City of Portland, Maine – Building or Use Permit Application 389 Congress Street, 04101, Tel: (207) 874-8703, FAX: 874-8716

REASON FOR PERMIT: rebuild porch, walkways & stairs

Re: Mr Robert Haines (Stairway request)

Robert C. Hainz
12 Gilman Street Walkways + Decks
Sheet #1

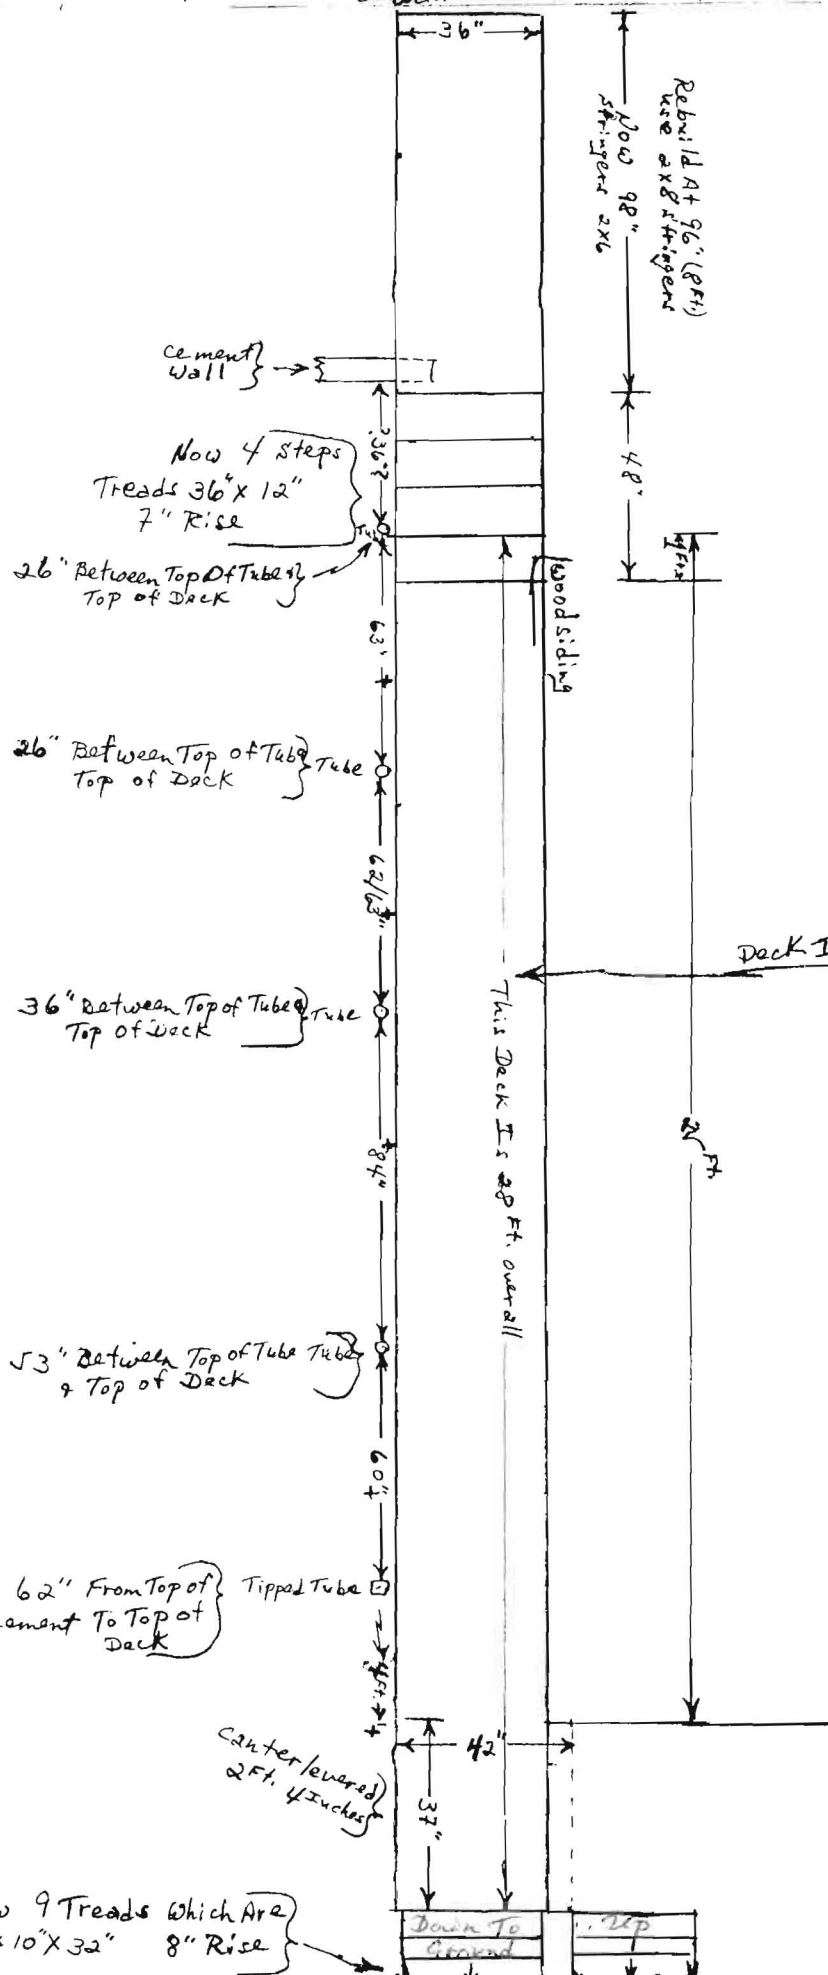
20 Jan 98 - This permit was issued after the fact - This was a replacement therefore some code requirement could not be met. 21/Jan/98 Check stair - Handrail grip too large - openings between stair tread and guard too large.

26 Jan 98 - Check area, work stopped - Mr. Hains looking for waivers on guards & handrails.

27 Jan 98 - Mr. Hains came to this office for info on guards and handrails. I gave him copies of code - # 10 - Feb - 98 inspected stairway (fire escape) work about 98% completed. Needs handrails - (Lt. McDougal P.F.D. myself).

23 - Mar 98 Check area with Lt. McDougal; Two areas need railing. Top of run - and first 5 steps. 6 MAY 98 work completed to point of acceptance. (meets intent of code) #1

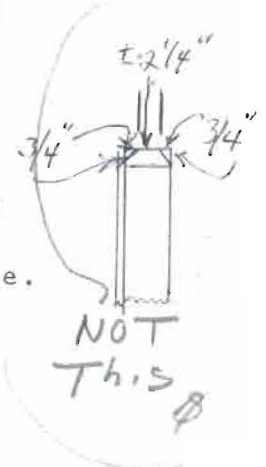
Item two) The hand rails: It has been suggested that I request of you a variance to waive the "1 1/4 to 2 inch round graspable hand rail" in favor of continuing to use the 2 X 4 style of rail that previously existed; see BOCA Code S1022.2.4 as to hand rail requirements. As you are aware this is an outside walk, exposed to the weather; be it sunshine, rain or snow. I suspect that this means of egress has existed since the 1920's. The main stairway ends 16 feet in the air and begins approximately 24 feet in the air and hangs - exposed - off the side of the building. I would think the more solid the better.

The word here is Handrail grip size.

A couple of suggestions have been made to resolve the hand rail issue. One is to drop the plywood one inch below the top 2 X 4. The second is to mitre the 2 X 4 and plywood at a 45 degree angle by approximately 3/4's of an inch on each of the top sides. This would be my preference.

Request #2 I feel that Mr. Haines can meet this requirement and should meet this requirement.
